Subject: N192212610 - Customer Satisfaction Program
Corrosion In Connector To Power Take-Off (PTO) Module

Models: 2019 Chevrolet Silverado 4500/5500/6500

N192212610 – Corrosion In Connector To Power Take-Off (PTO) Module

5318484

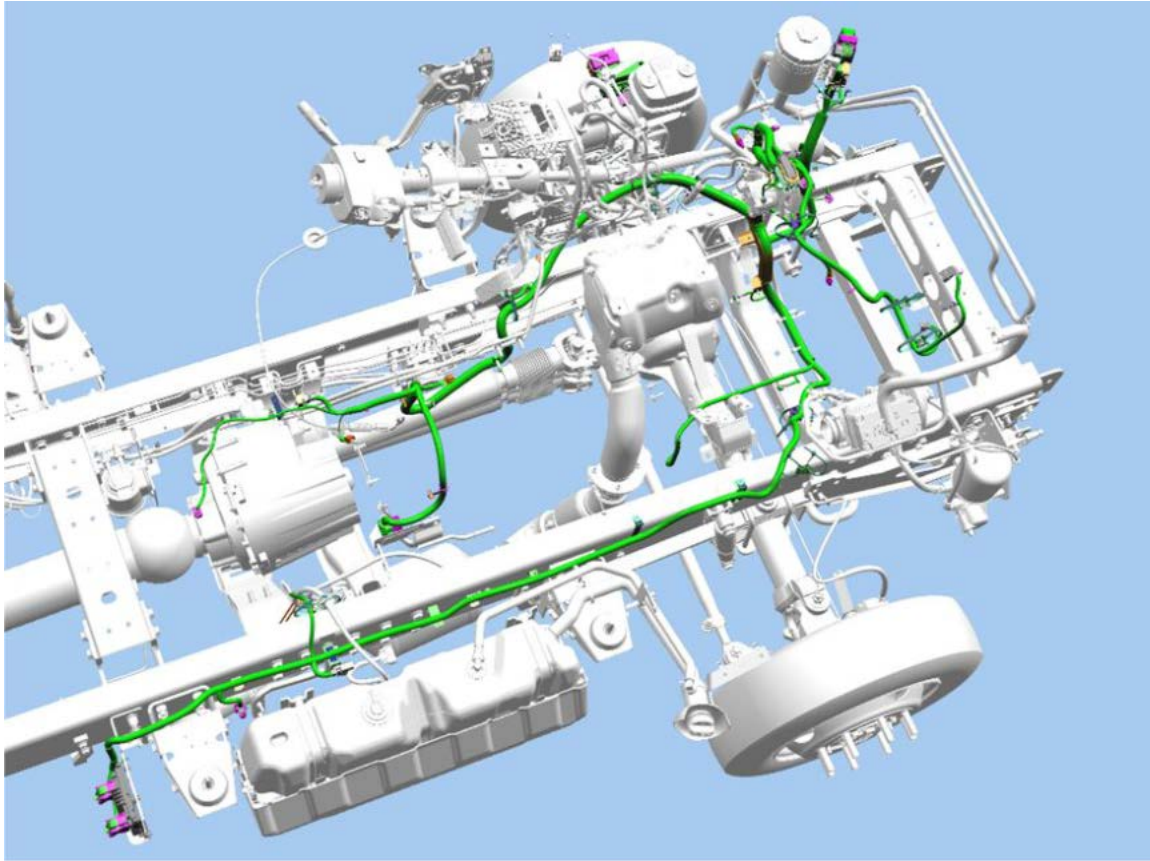
Condition	Certain 2019 model year Chevrolet Silverado 4500/5500/6500 vehicles may have a Power Take Off (PTO) connector that has inadequate protection against water/debris intrusion. Over time, this could affect the function of the upfit (if so equipped) and the vehicle may exhibit reduced engine power and/or fail to restart.
Correction	Replace the engine wire harness and PTO Module.

1. Replace the engine wire harness as outlined in green in the illustration above (there may be minor variations depending on truck options, use the new part as a guideline).
2. Replace the PTO module. Refer to *Engine Speed Power Take-Off Control Module Replacement* and *K44 Power Take-Off Control Module: Programming and Setup* in SI.
